SIB 11 06 21

N63M, N63B and S63M Engine: Engine Oil Filter Kit Availability and Alternatives

This Service Information Bulletin (Revision 2) replaces SI B11 06 21 **dated April 2022**.

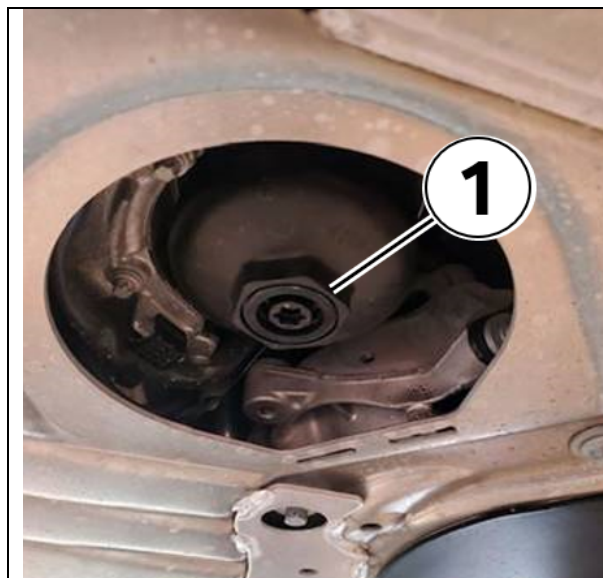
The vehicle may or may not have an engine oil filter cap with a plastic drain plug located in the center (1).

Do not remove the engine oil filter drain plug until further notice.

Set oil filter element P/N 11 42 7 583 220 and P/N 11 42 7 848 321 do not have the O-ring for this drain plug included in the contents.

Remove the entire engine oil filter cap to drain the engine oil and remove the engine oil filter.
